Access Compliance Report

Public Rights-of-Way

(Curb Ramps)

Intersection ID: 49922	Main Street: AUSTIN_DEKOTA_DR	Cross Street: LESLIE_DR	Location: S
ADA ID: 44C72AC867F5	Ramp Type: PerpDiag	Initial Pass/Fail: Fail	Overall Compliance: No
Codes/Mitigation Info/Possible Solution		Field Measurements/Component Compliance	
Severity Score: 33.75

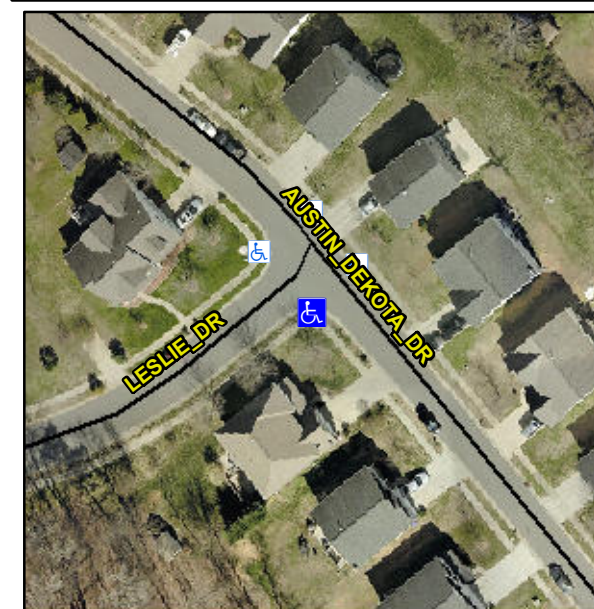
Not Found, R304.5.1, R304.2.2, R304.5.3

Compliance	Description	Data	Compliance	Description	Data
N/A	Ramp Length (in)	50.0	No	Ramp Slope (%)	9.4
No	Ramp Width (in)	43.0	No	Ramp XSlope (%)	5.3
N/A	Flare Type LT	N/A	N/A	Flare Type RT	N/A
N/A	Flare Slope LT (%)	N/A	N/A	Flare Slope RT (%)	N/A
N/A	Flare Traversable LT?	N/A	N/A	Flare Traversable RT?	N/A
N/A	Landing Length (in)	N/A	N/A	DWS Provided?	N/A
N/A	Landing Width (in)	N/A	N/A	DWS Contrast?	N/A
N/A	Landing Slope (%)	N/A	N/A	DWS Length (in)	N/A
N/A	Landing X Slope (%)	N/A	N/A	DWS Full Width?	N/A
N/A	Landing Curb? (Y/N)	N/A	N/A	DWS Offset (in)	N/A
N/A	Shared Landing?	N/A			
N/A	Gutter Ponding?	N/A	N/A	Gutter Slope (%)	N/A
N/A	Gutter Lip Ht (in)	1.5	N/A	Gutter X Slope (%)	N/A
N/A	Painted X Walk1?	No	N/A	Painted X Walk2?	No
	X Walk 1 Direction	To NE		X Walk 2 Direction	To NW
N/A	X Walk 1 Width (in)	N/A	N/A	X Walk 2 Width (in)	N/A
	X Walk 1 Slope (%)	2.4		X Walk 2 Slope (%)	4.5
	X Walk 1 X Slope (%)	4.4		X Walk 2 X Slope (%)	0.1

Remove & Replace Curb Ramp With Two New Directional Ramps or Equivalent.
